### ADDENDUM NO. 1

To the Drawings and Project Manual dated 16 June 2017

**TAS/ADA FIRE MARSHAL  
DEFERRED MAINTENANCE PROJECTS  
MIDWESTERN STATE  
UNIVERSITY**

Addendum Date: 2 August 2017

**BOLIN SCIENCE HALL - ELECTRICAL ONE LINE ELECTRICAL PLAN**

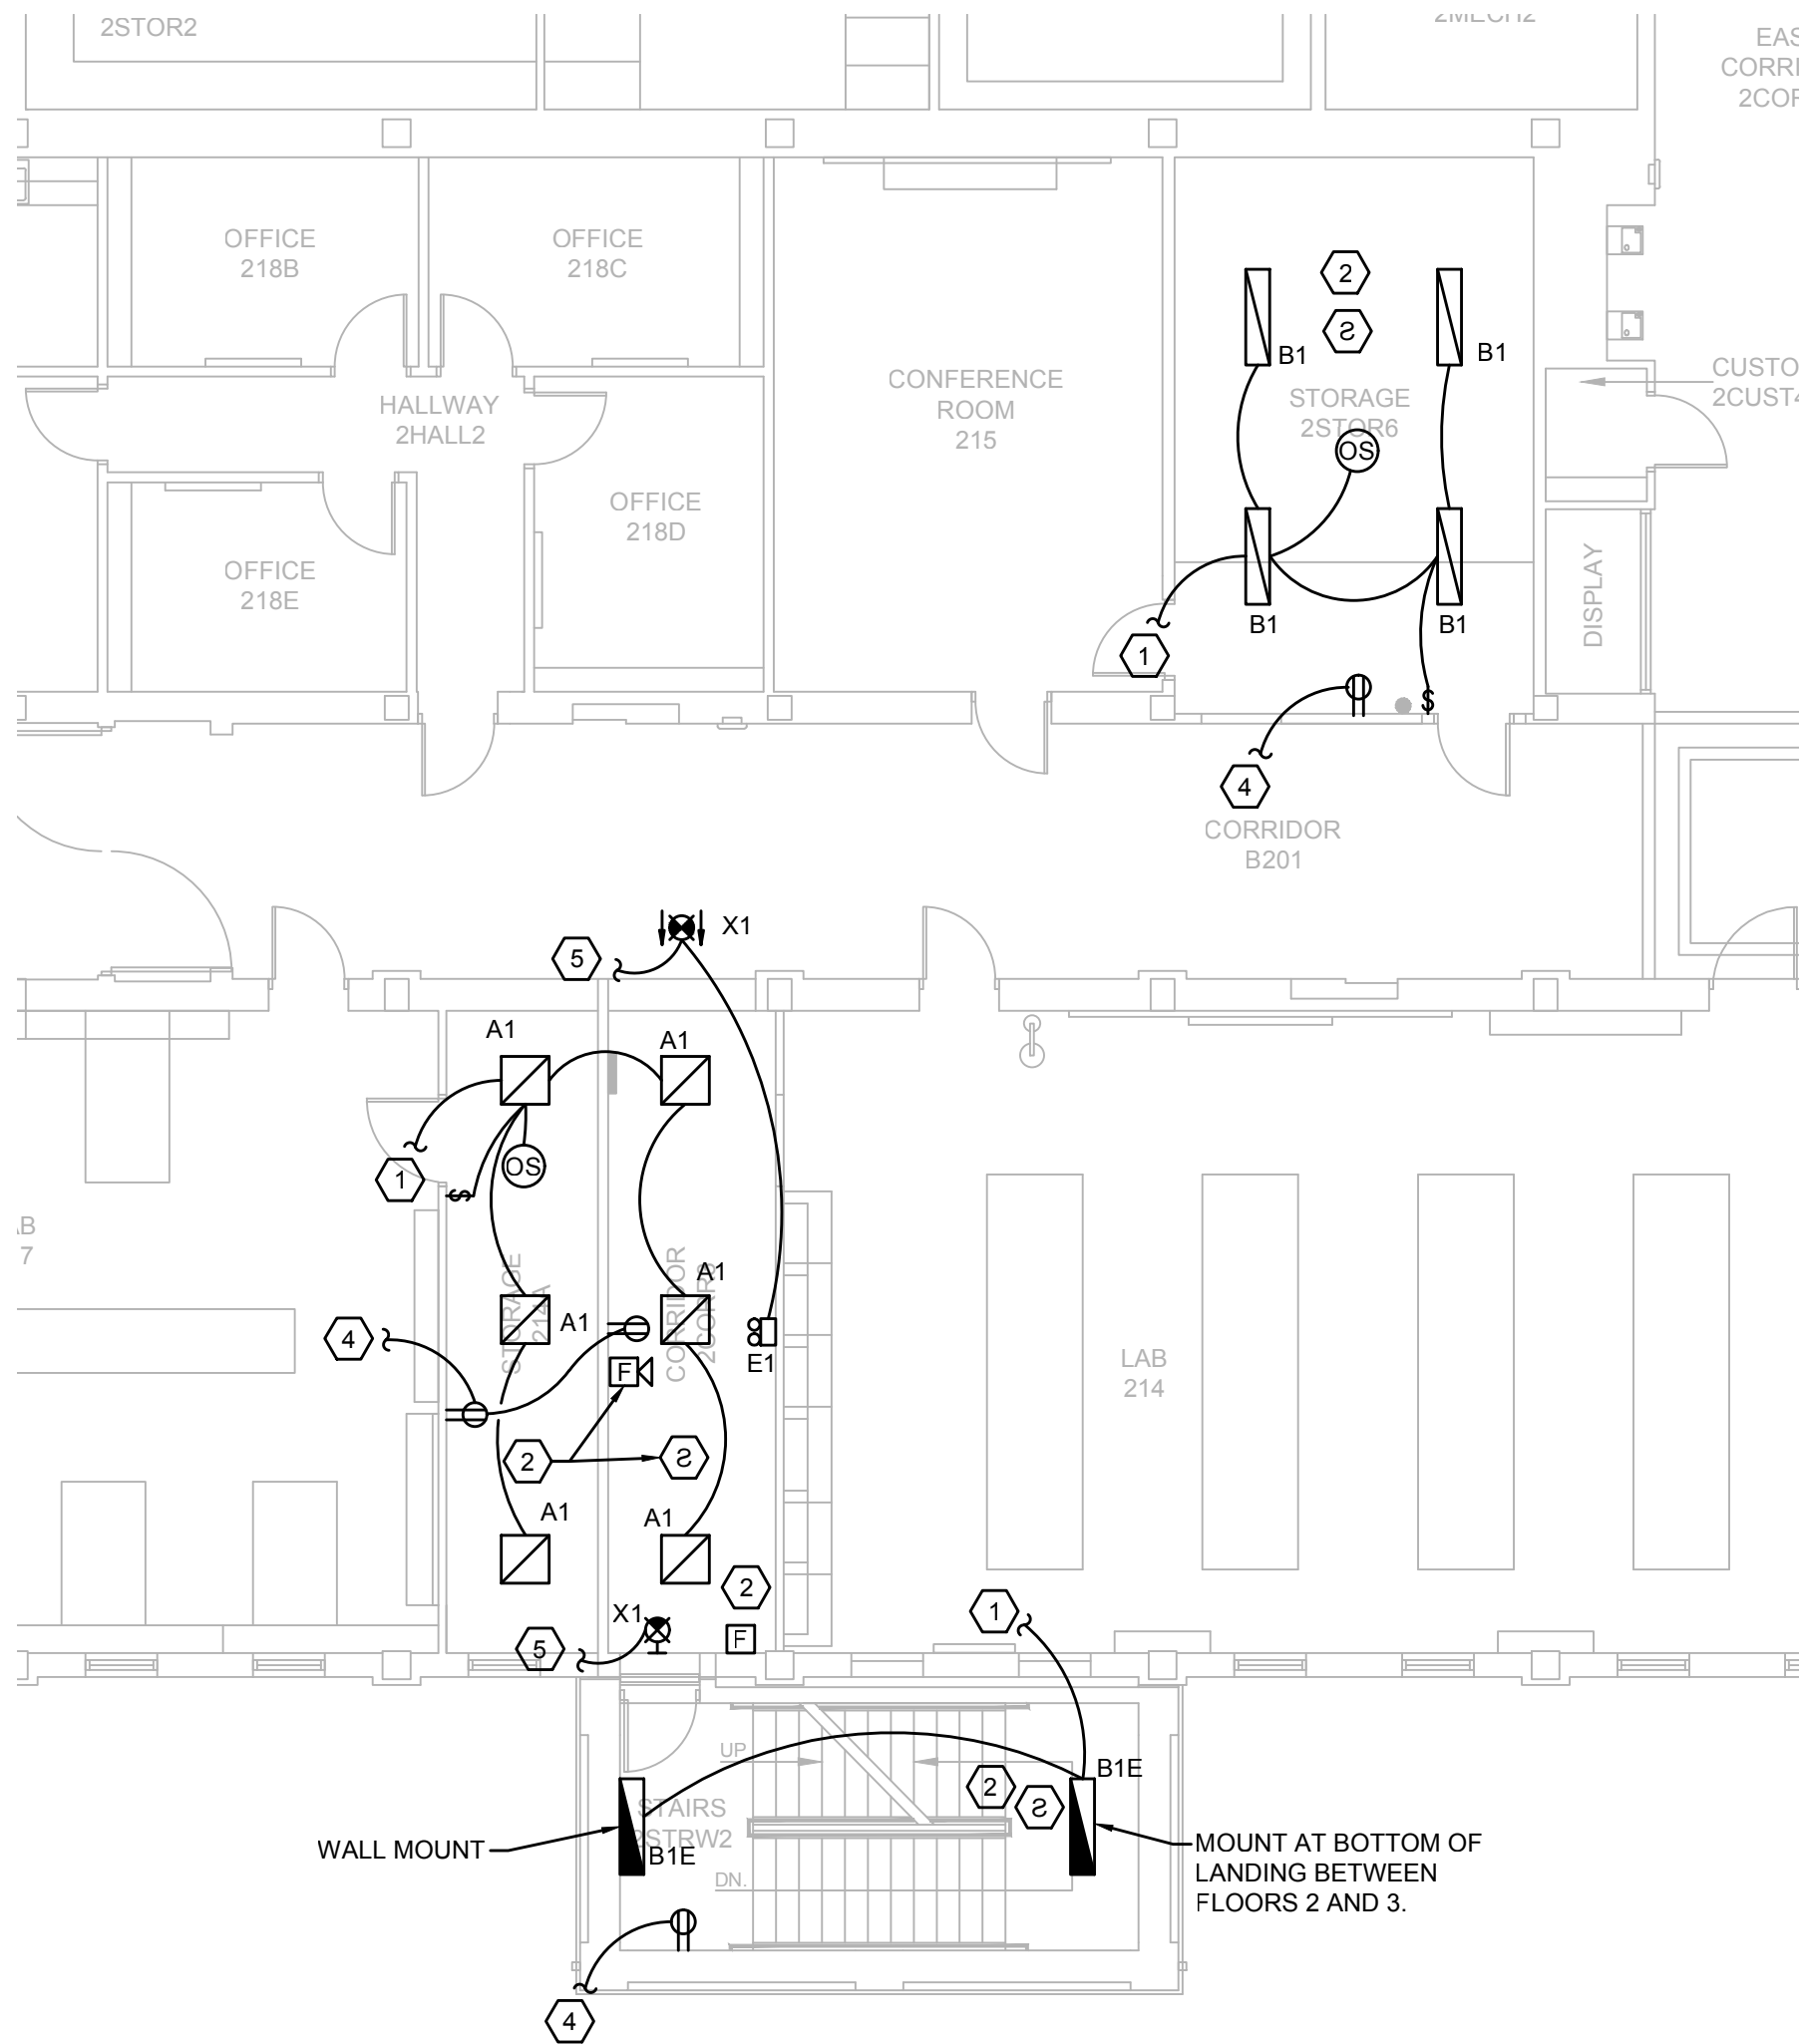
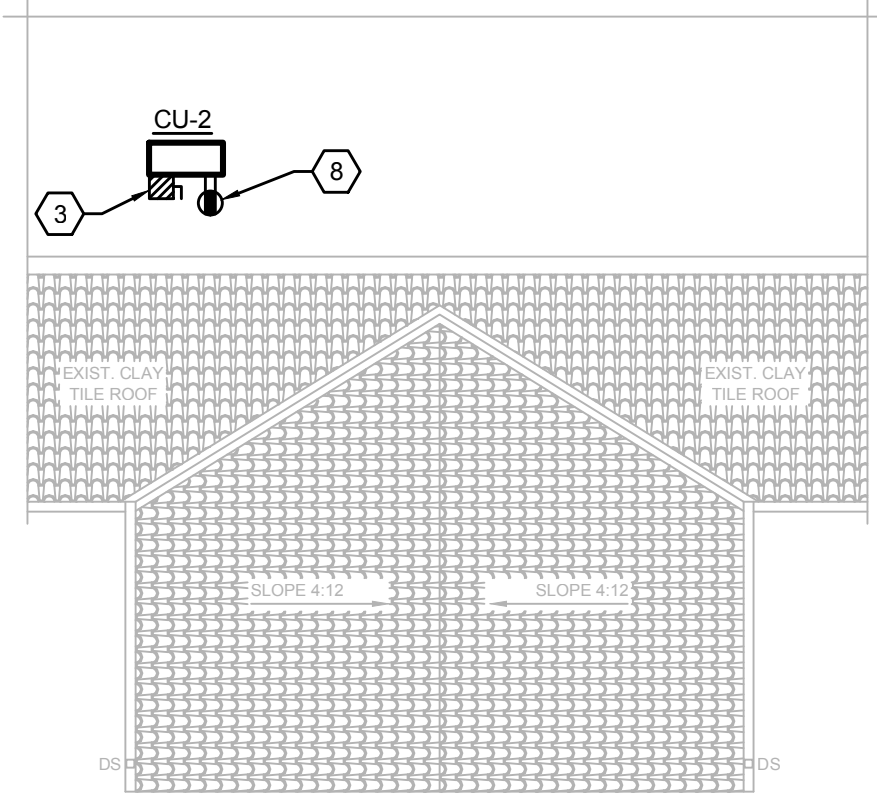
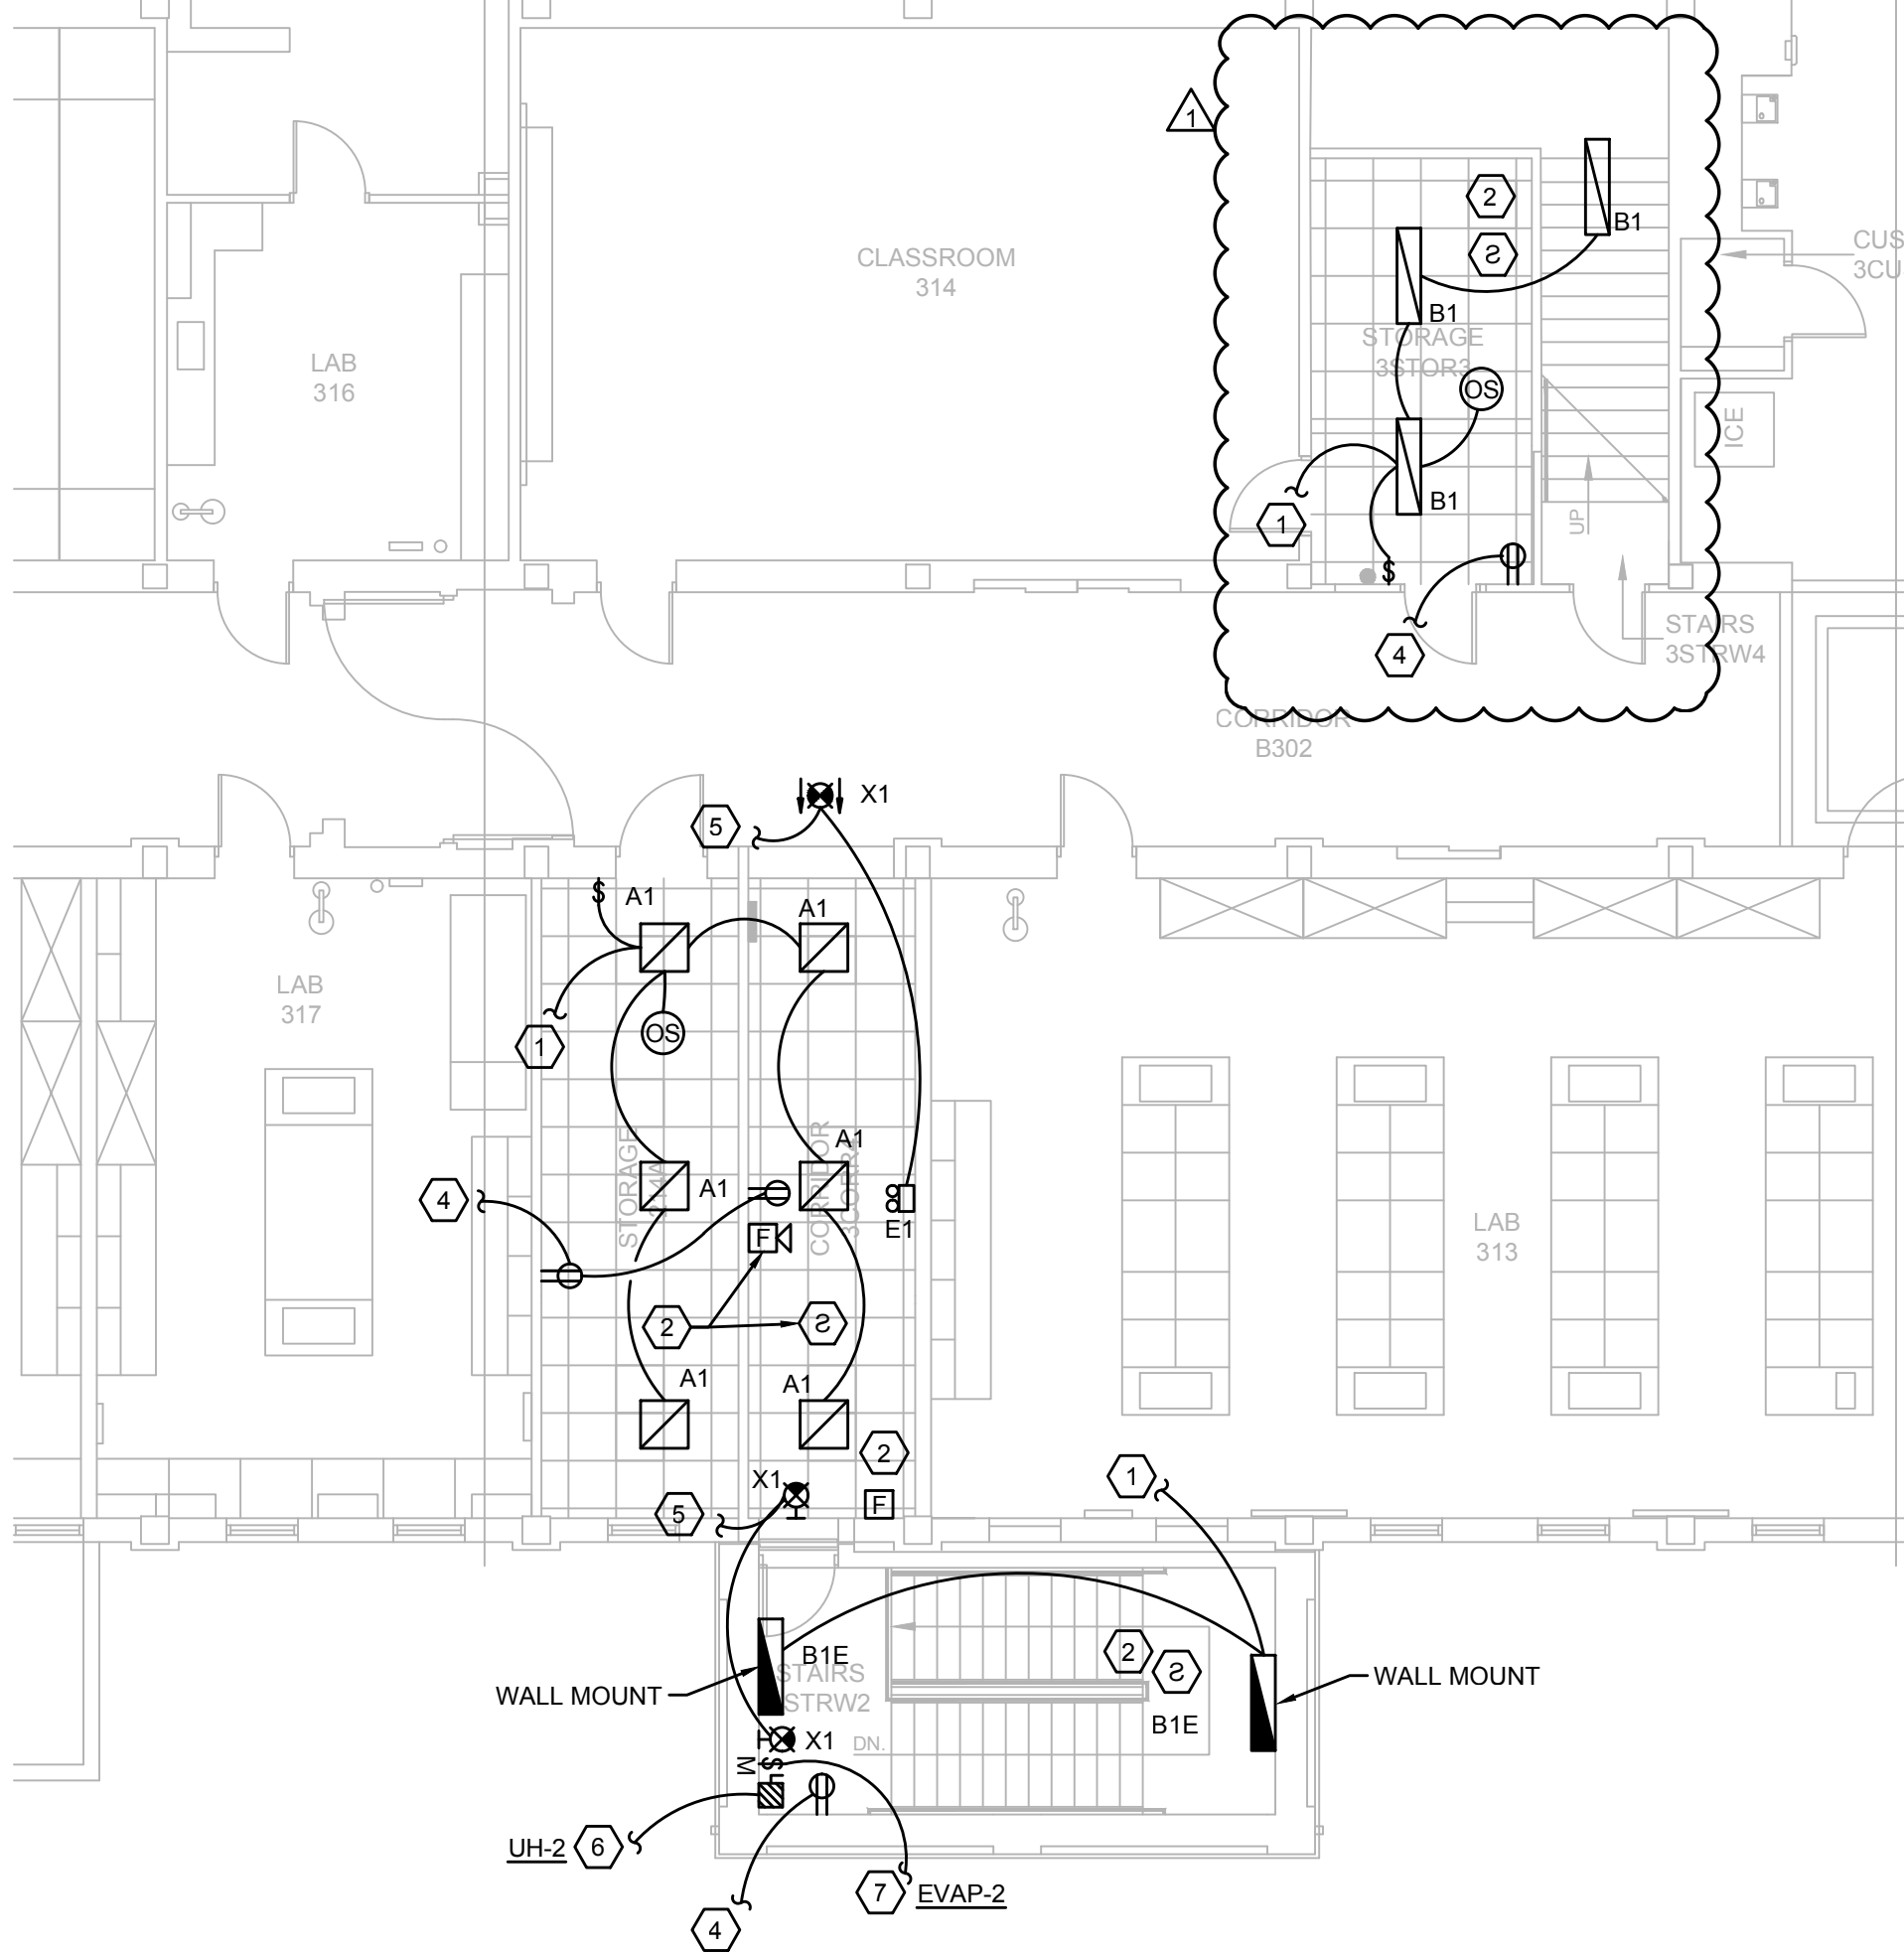
3. Sheet B-E102 – Revised Drawing as follows:
  - a. Adjusted location of lighting fixture in drawing 1/BE102 to conform on architect's RCP.
  - b. Changed notes in drawing 4/B-E102; removed transformer voltage, 277V inserted in MDP description, and noted that pvc is in ductbank.
